REGIONAL REVIEW NOTICE

ARC REVIEW CODE: R1207121

Name of Proposal: DCT River West Distribution Center

DCT RIVER WEST DISTRIBUTION CENTER DRI
Douglas County
ARC Environmental Planning Division Comments
July 11, 2012

C4.0

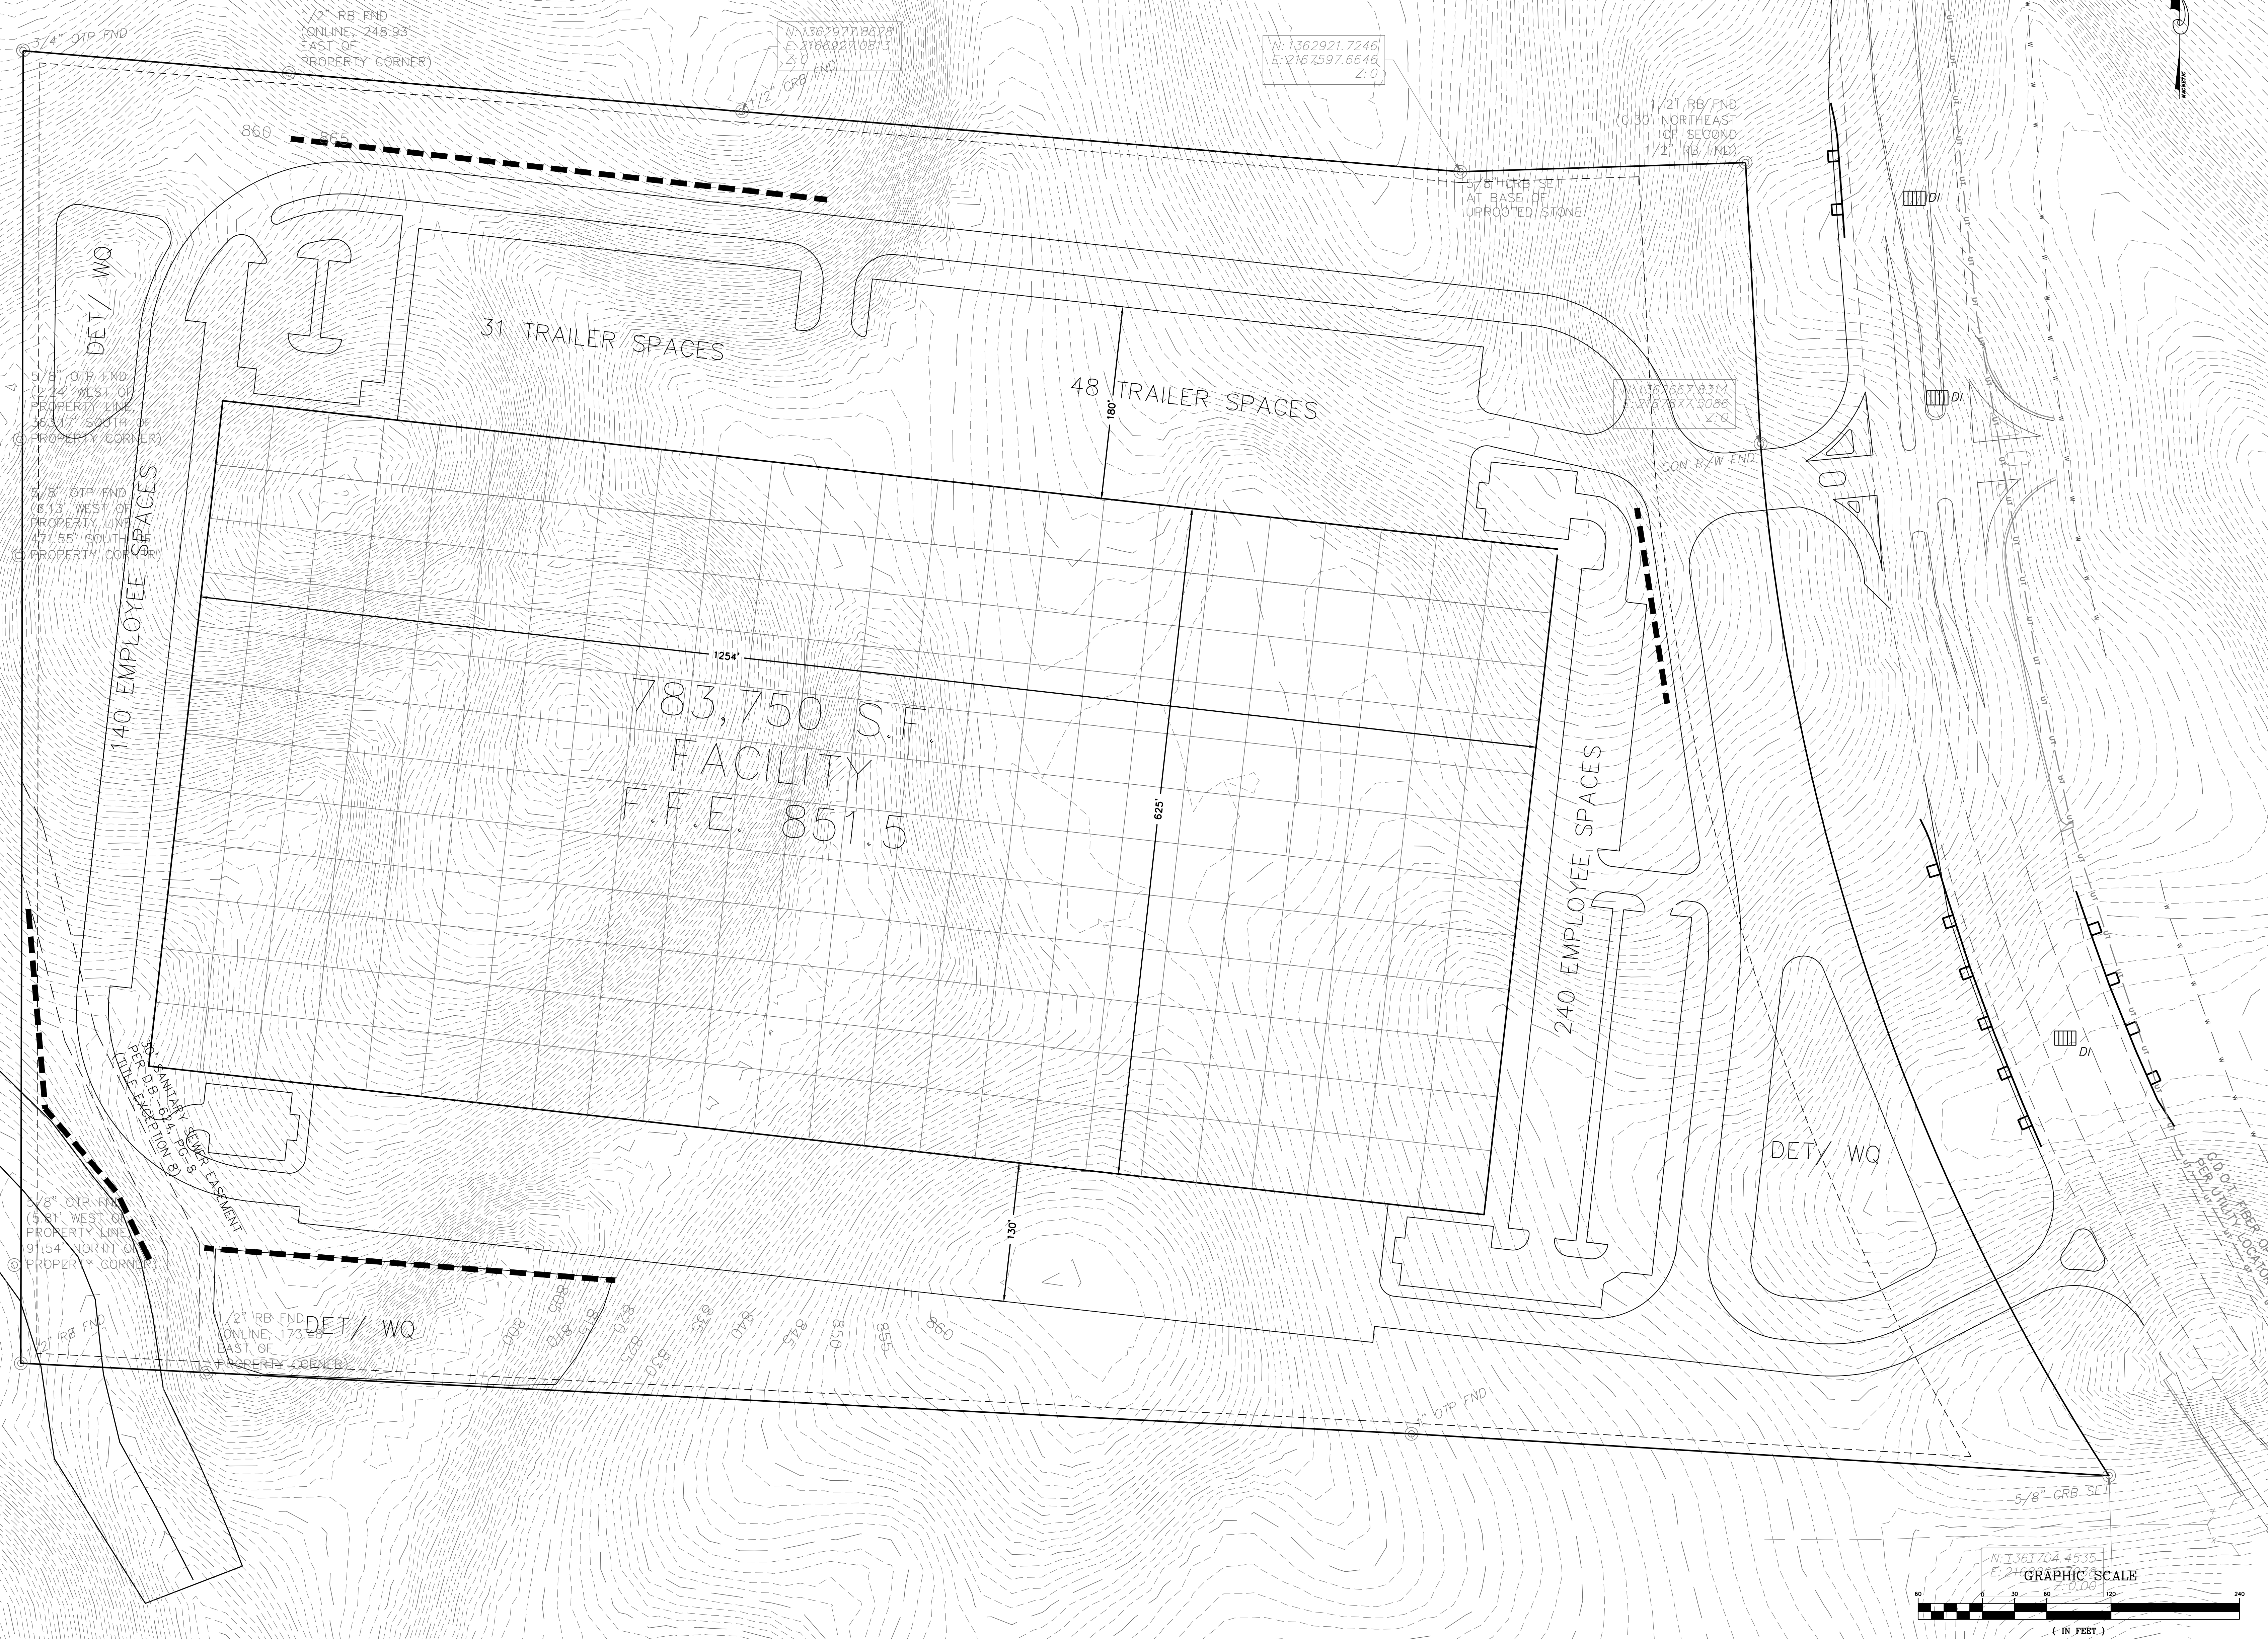
Site access is intended to be provided for the warehouse/distribution building of the DRI via two driveways off Thornton Road, south of the intersection with Douglas Hill Road. The main driveway to the north is located at an existing median opening. This median opening also serves another warehouse use that is located along the east side of Thornton Road. The second driveway to the south is a proposed right-in right-out and is located approximately 550 feet to the south of the main driveway.
